July 9, 2018

Revised January 13, 2021

**Re: Amended Certificate of Appropriateness
Sabbagh Residence
308 Spier Avenue
Lot 6, Block 13
Borough of Allenhurst
Our File: ALPB 18-06**

**Re: Proposed Lawn Sump Drainage Plan
308 Spier Avenue
Lot 6, Block 13
Our File ALPB 19-01**

Borough of Allenhurst – 1930 Sanborn Map
 308 Spier Avenue
 Lot 6 Block 13
 Sabbagh Residence

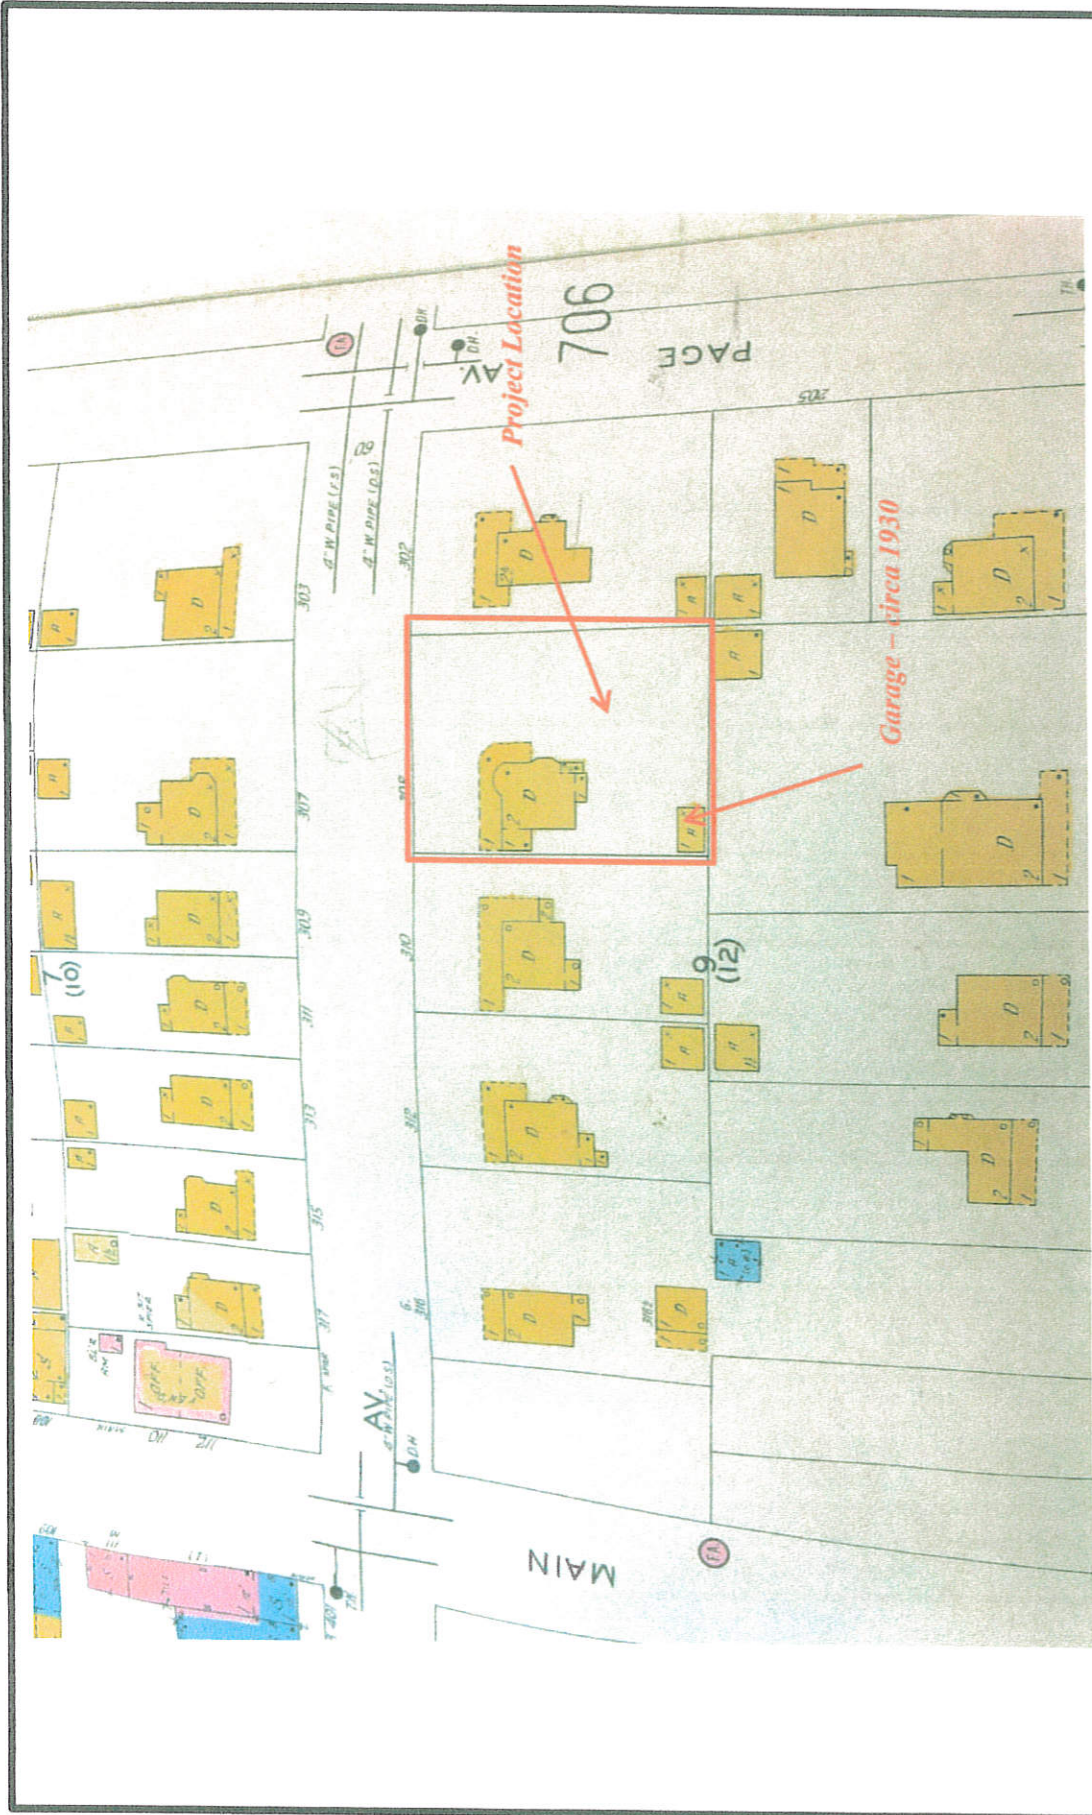
- D. Ordinance Section 26-4.4.g.6 requires all private garages shall have a driveway that leads to at least one (1) primary garage door. The Applicant does not propose a driveway to the detached garage. **Existing non-conformity.**
- E. Attached please find a copy of 1930 Sanborn map. The map indicates the rear building was a garage during that time period. Testimony on the actual use shall be provided. The historic registry lists the rear building as a pool house.
- F. Impervious Coverage Summary
